**Development
Application
Permit
Review**

PARKS AND COMMUNITY SERVICES DEPARTMENT

Name:	Mayberry Filing No.5	Application Type:	PUDSP
PCD Reference #:	PUDSP233	Total Acreage:	8.31
Applicant / Owner:	Owner's Representative:	Total # of Dwelling Units:	146
Mayberry Communities	Kimley-Horn & Associates	Dwelling Units Per 2.5 Acres:	43.92
Scott Sauder	Larry Salazar	Regional Park Area:	4
32823 Temecula Parkway	2. North Nevada Ave, Suite 900	Urban Park Area:	5
Temecula, CA 92592	Colorado Springs, CO 80903	Existing Zoning Code:	PUD
		Proposed Zoning Code:	PUD

Agenda Item Title: Mayberry Filing No. 5 Preliminary Plan

Mayberry Filing No.5 Preliminary Plan / PUD

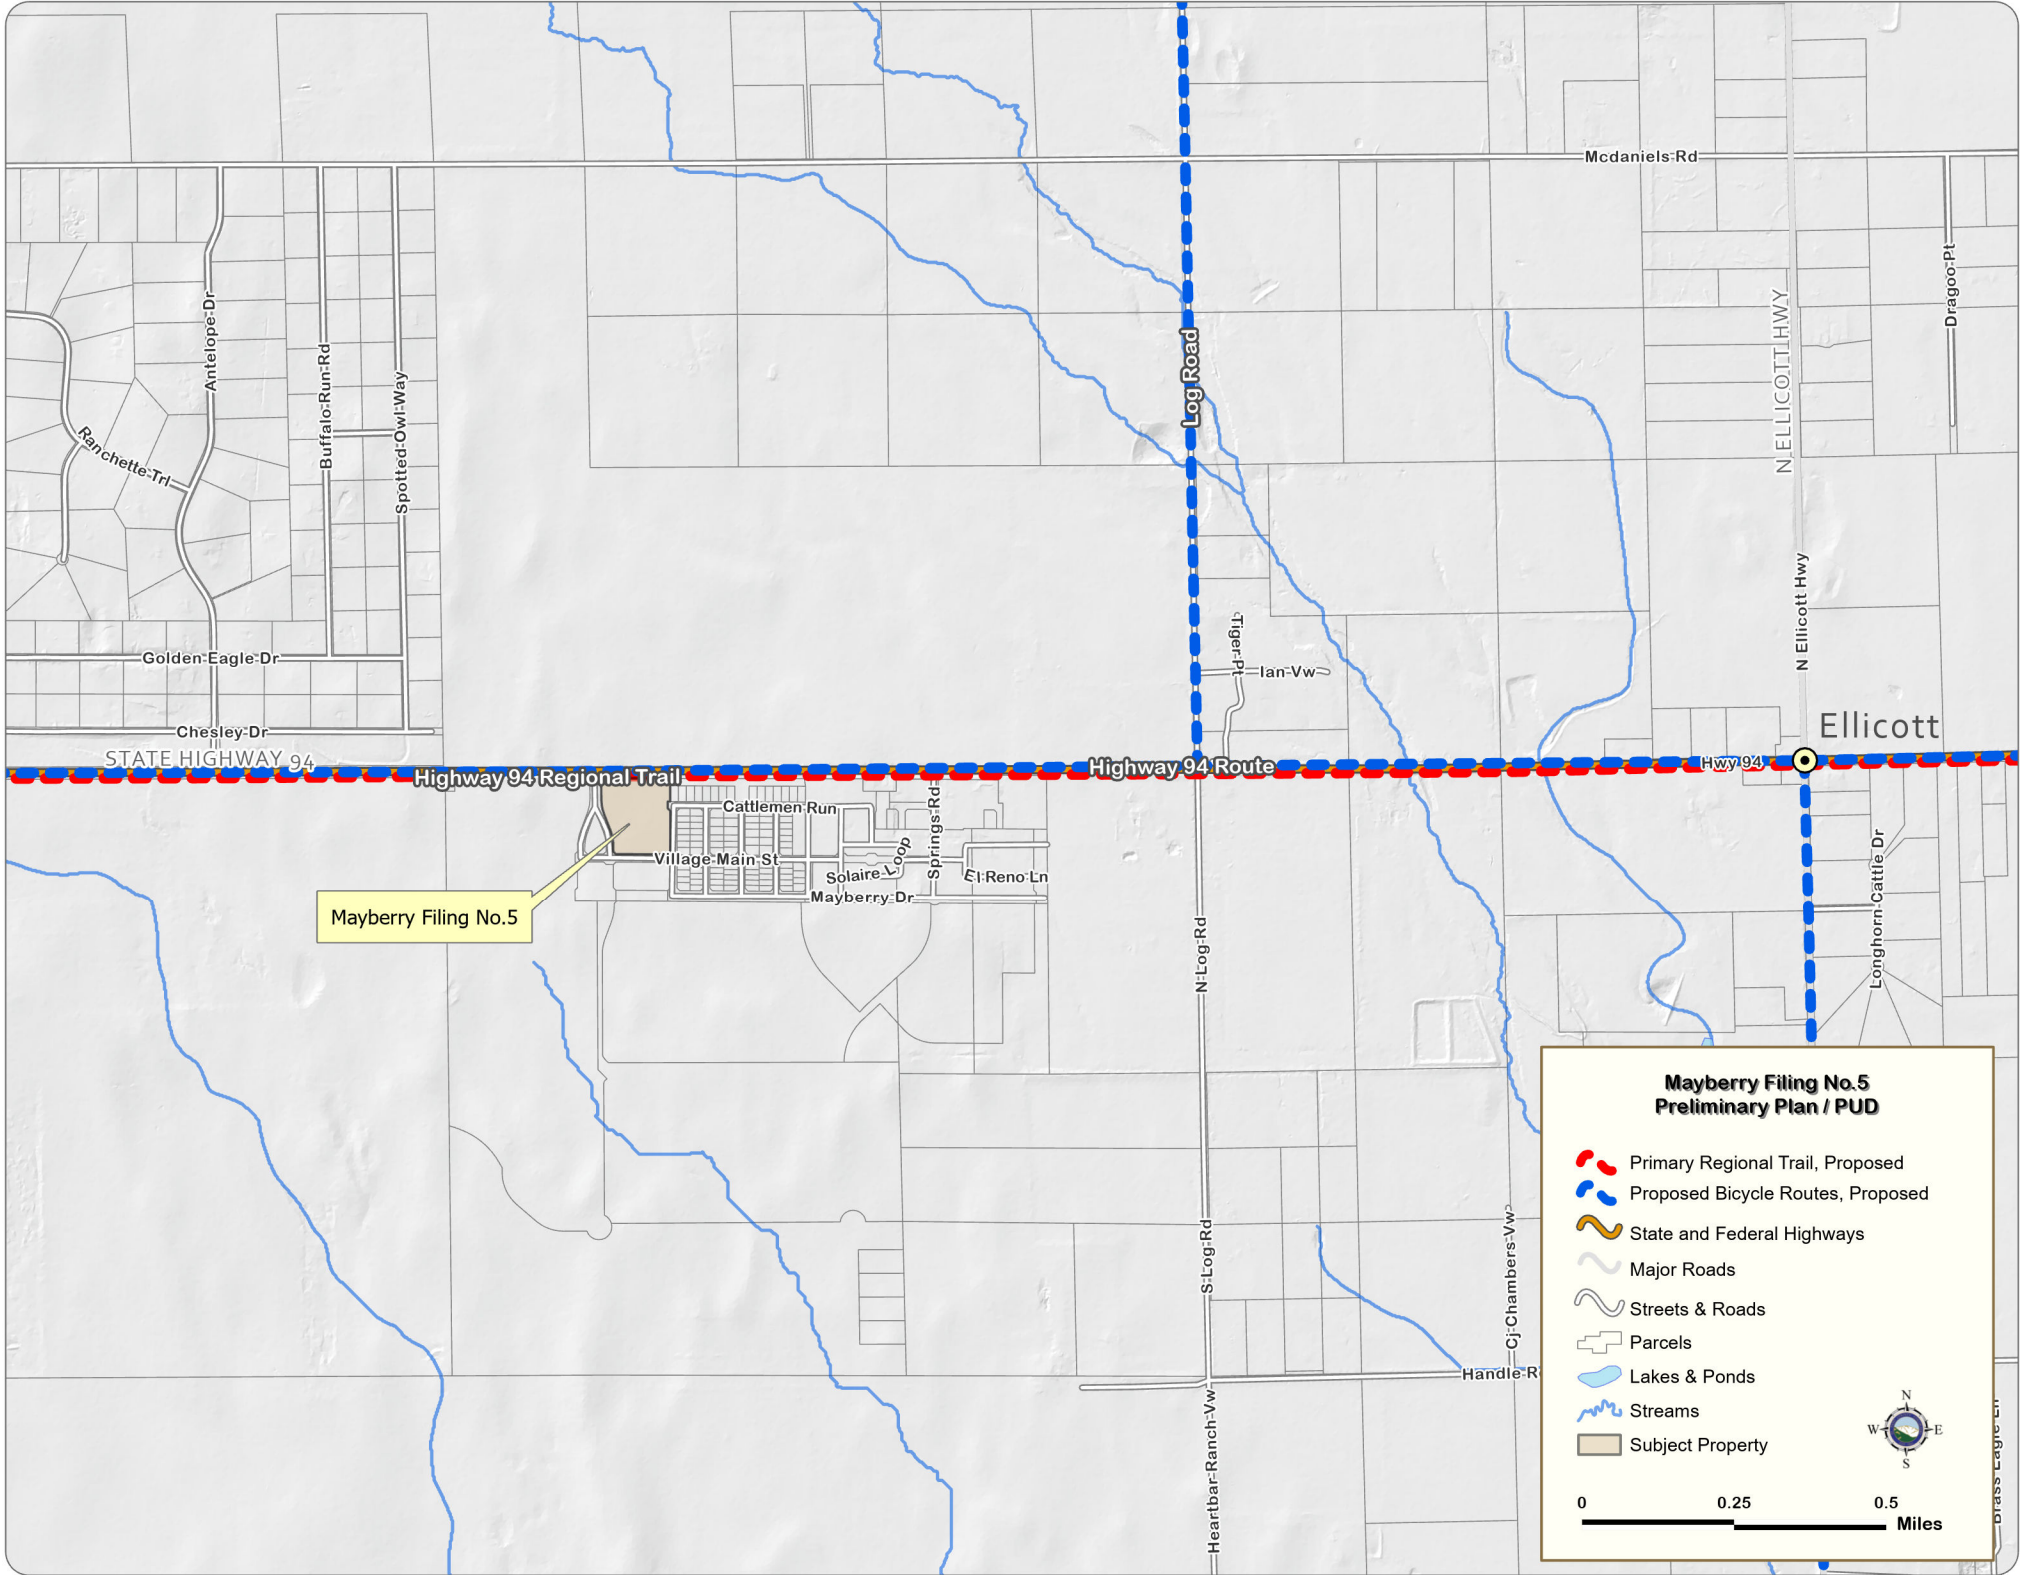
Mayberry Filing 5 shows an 8' sidewalk south of Highway 94 along the north property line of the site. The proposed 8' wide sidewalk would be an acceptable alignment for the Highway 94 Regional Trail, provided it has connections at the east and west end of the site to the future Highway 94 Regional Trail. According to the plan, the 8' wide sidewalk ends at the apartment buildings on the east end of the site and tees into an internal sidewalk. The 8' wide sidewalk shall be shown to connect to the future Highway 94

Regional Trail alignment to the east instead. At the west end of the project, the 8' wide sidewalk is shown ending at Mayberry Drive and teeing into a 7' wide internal north-south sidewalk. A tree is shown west of this intersection. Instead, the Highway 94 Regional Trail should be shown with a future connection to the west of Mayberry Drive with a crosswalk at the intersection.

County Parks requests trail easements where development projects impact proposed County trails. As it pertains to this application, the County requests that the landowner provide a 25-foot public trail easement along the south side of Highway 94 that allows for the construction and maintenance by El Paso County of the Highway 94 Primary Regional Trail, and this easement shall be shown and dedicated to El Paso County on the Final Plat.

Pedestrian Crossing

Connect 8' Sidewalk with regional trail
